## Objection to Heritage Foundation Application 33 Parker Close

As owner-occupiers [REDACTED] an adjacent property, we would like to contest the planning application for 33 Parker Close for two reasons:

Figure 1: View of side aspect of 33 Parker Close from kitchen-diner / family area of [REDACTED]

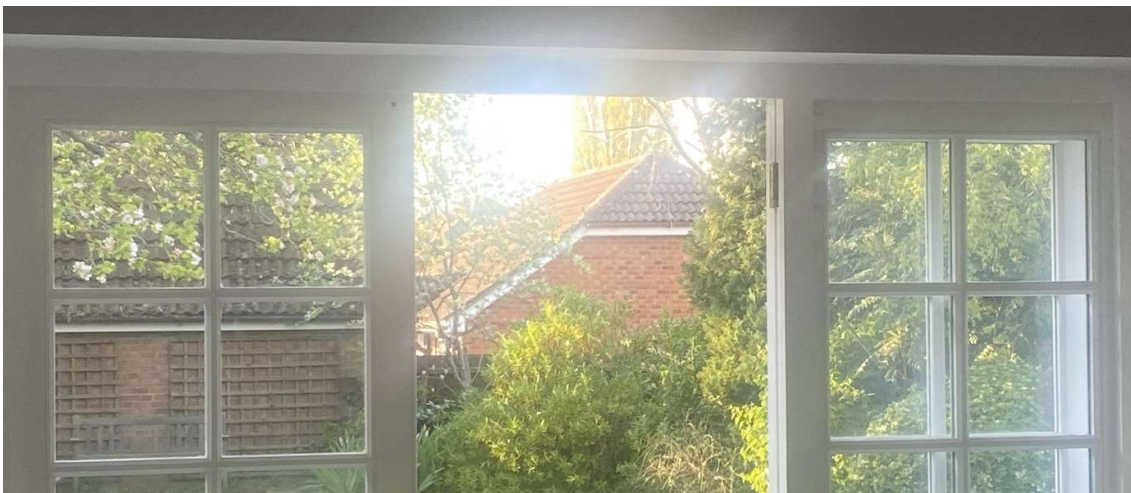
The proposed extension will allow the occupants of 33 Parker Close to overlook [REDACTED] back garden and see directly into [REDACTED] kitchen-diner / family area. The extent of this loss of privacy can be seen from figures 1-3 below. Note: The pictures were taken in spring. In winter, without foliage the visibility will be even clearer.

As the pictures above show, the proposal does not meet the Heritage Foundation guideline: "Extensions shall not lead to an unacceptable loss of amenity to neighbouring occupiers."

*Windows in the flank of extensions that cause overlooking shall be avoided*". The proposed extension will result in a loss of privacy as it will allow the occupants of 33 Parker Close to see directly from their proposed kitchen-diner, which will no doubt be a frequently used area of their home, into [REDACTED] kitchen-diner / family area, a part of our home frequently used by [REDACTED]. The window of [REDACTED] downstairs loo will also be visible from the proposed windows. This would result in a significant loss to [REDACTED] privacy and [REDACTED] habits and daily routines may need to be adjusted to take this into account. [REDACTED] back garden will also be overlooked and may also affect [REDACTED] outdoor activities too.
